PROJECT NAME: MARION OAKS UNIT 9 TOWNHOMES

PROJECT NUMBER: 2024070047

APPLICATION: MINOR SITE PLAN #31785

**DEVELOPMENT REVIEW COMMITTEE WAIVER REQUEST FORM**

A MARION COUNTY MINOR SITE PLAN FOR MARION OAKS UNIT 9 TOWNHOMES MARION COUNTY Lanar & Ullip, Plan

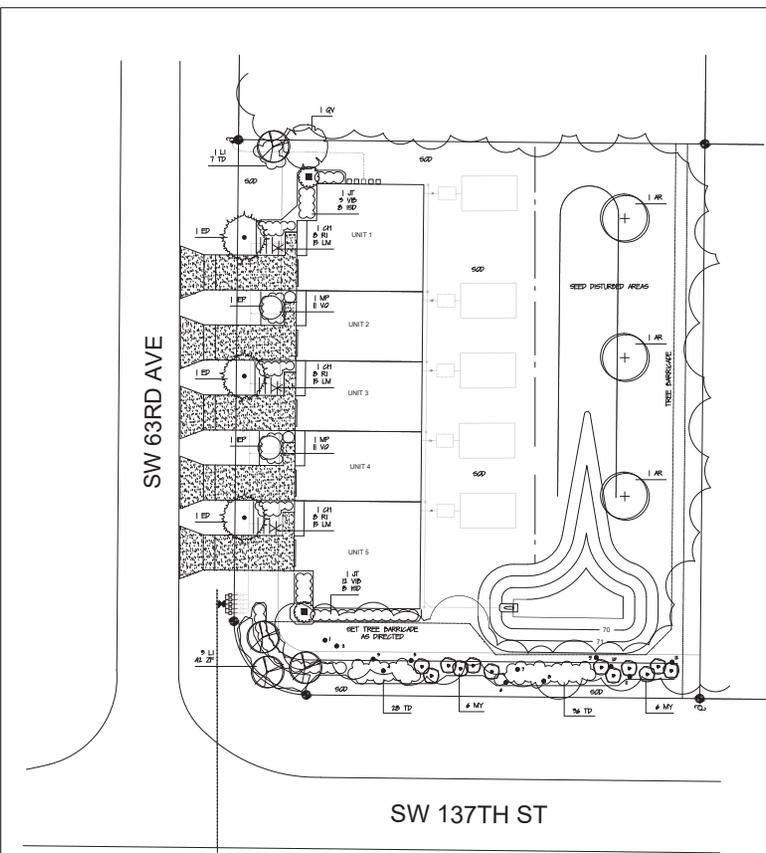
- 5 DEPARTMENT: ZONE - ZONING DEPARTMENT  
REVIEW ITEM: Additional Zoning Comments  
STATUS OF REVIEW: NO  
REMARKS: LDC Section 6.11.5.D(3) that states: "Multi-family sites require adequate vehicular maneuvering area off of the right-of-way to prohibit backing out of driveway." The current plan shows five multiple-family dwellings each with an individual driveway backing out directly into the local road right-of-way, just north of SW 137th Street that is the east/west subdivision collect through this area of Marion Oaks. A LDC Waiver must be obtained to proceed with the proposed design.

Section & Title of Code: Section 6.11.5.D(3) Residential Driveway Requirements  
Reason/Justification for Waiver Request: Waiver to allow four (4) driveway accesses to support a five (5) unit multi-family development. Sight triangles requirements are met. The closest access to intersection of SW 63rd Ave (local) and SW 137th Street (collector) is 72-ft. SW 63rd Ave is not a major local road, nor is it a through street. There are cul-de-sacs at its terminus. Therefore, only local residential traffic is anticipated in this area.  
(Attach sheet 3 for additional waivers)
